Access Compliance Report Public Rights-of-Way (Pedestrian Signals)

Intersection ID: N/A	Main Street:	Cross Street: N/A	Location: N/A
ADA ID: 5751BEDA8677	Signal Type: One Push Button-APS	Overall Compliance: No	Severity Score: BTN 1: N/A BTN 2: N/A No BTN: N/A
Codes/Mitigation Info/Possible Solution		Field Measurements/Component Compliance

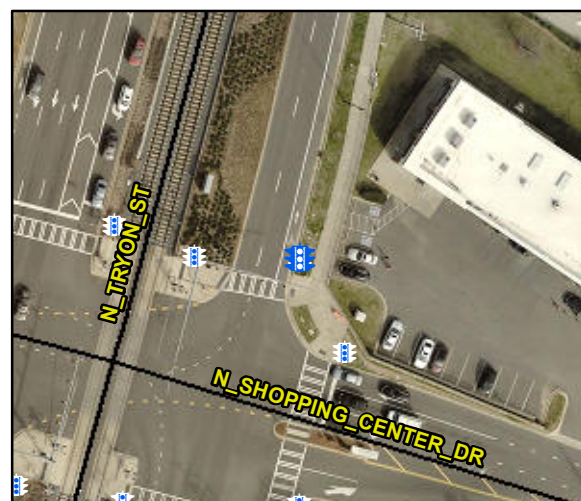
PROW/ADA: TMUTCD 4e.08, R404.2, R404.3, R404.7.2, R209.1, MUTCD 4e.10

N/A	B 1 Clear Xing Direction?	Yes	N/A	B 2 Clear Xing Direction?	N/A
	B 1 Crossing Direction	To W		B 2 Crossing Direction	N/A
No	B 1 DistanceTo XWalk (in)	72.0	N/A	B 2 DistanceTo XWalk (in)	N/A
Yes	B 1 DistanceTo Curb (in)	56.0	N/A	B 2 DistanceTo Curb (in)	N/A
Yes	B 1 Diameter (in)	2.0	N/A	B 2 Diameter (in)	N/A

Possible Solutions: Replace Signal Push Button With APS Button on New Post. Remove & Relocate Sign.
